Certificate of Appropriateness
1123 Williamson Street
November 15, 2021

Proposed Work

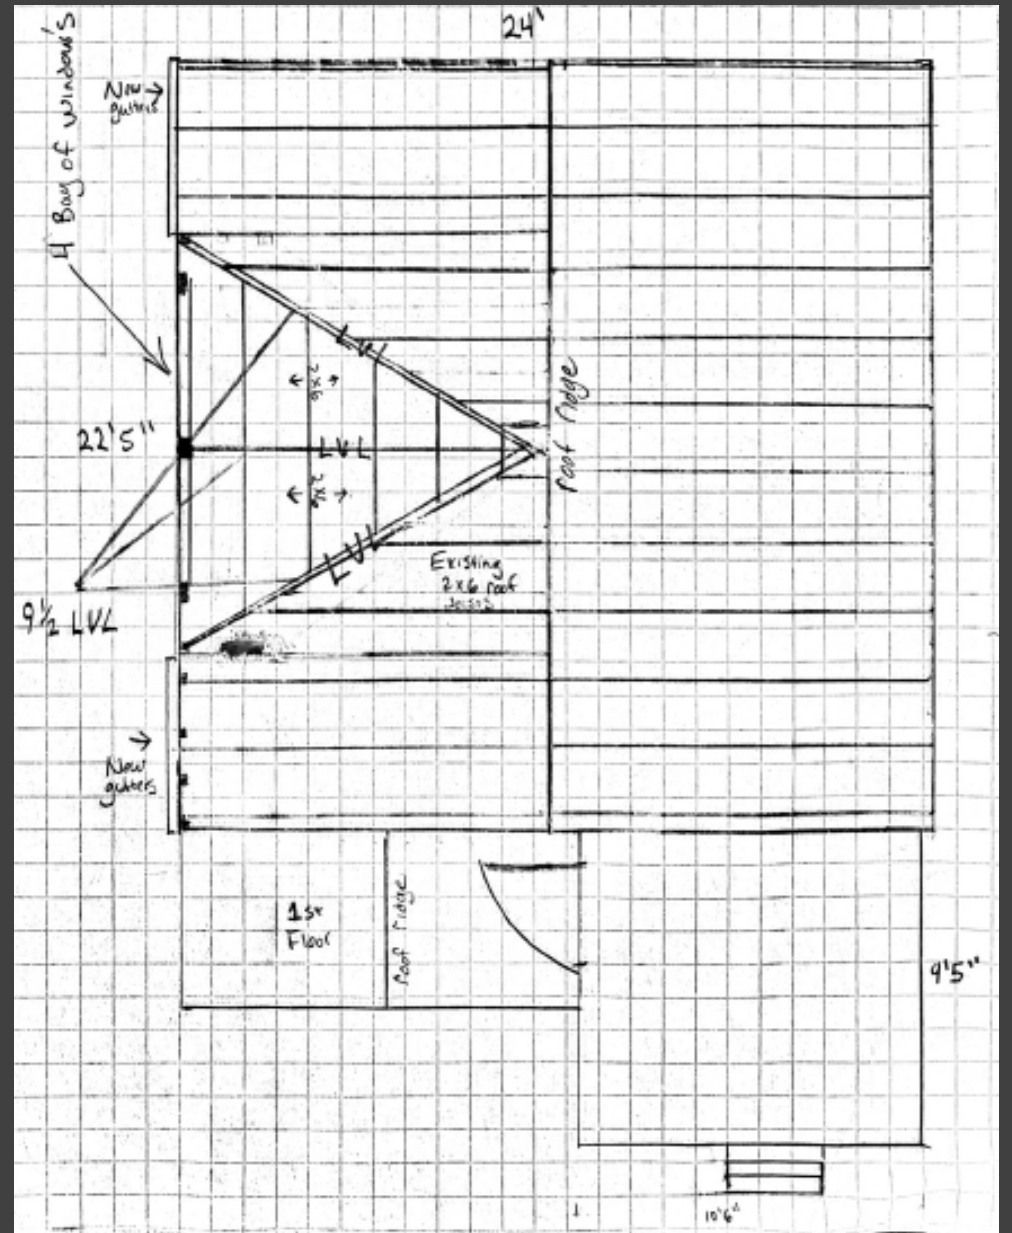
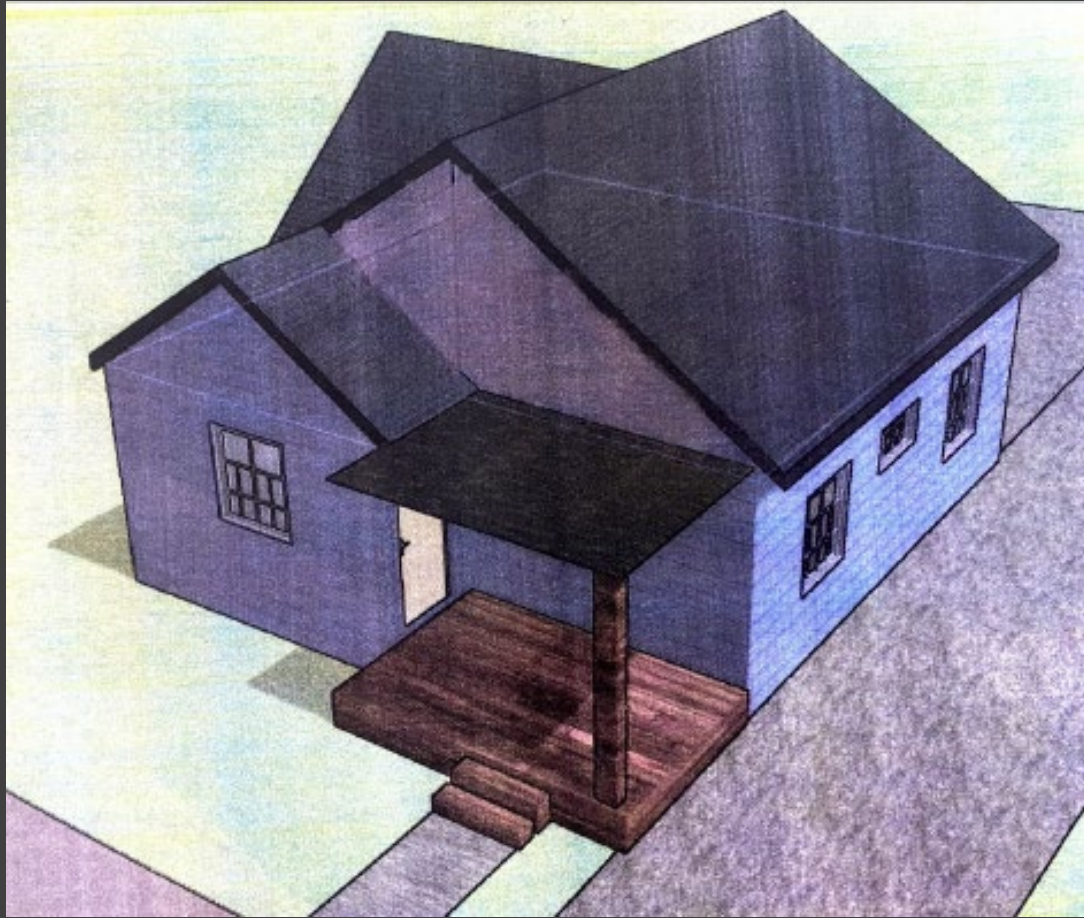
- Construction of 12-foot-wide dormer on east side
- Reroofing

Staff believes that the standards for granting a Certificate of Appropriateness could be met and recommends that the Landmarks Commission refer the project to a future meeting to allow the applicant to redesign for a 4-foot wide dormer or 4-foot wide dormers on each side of the roof.
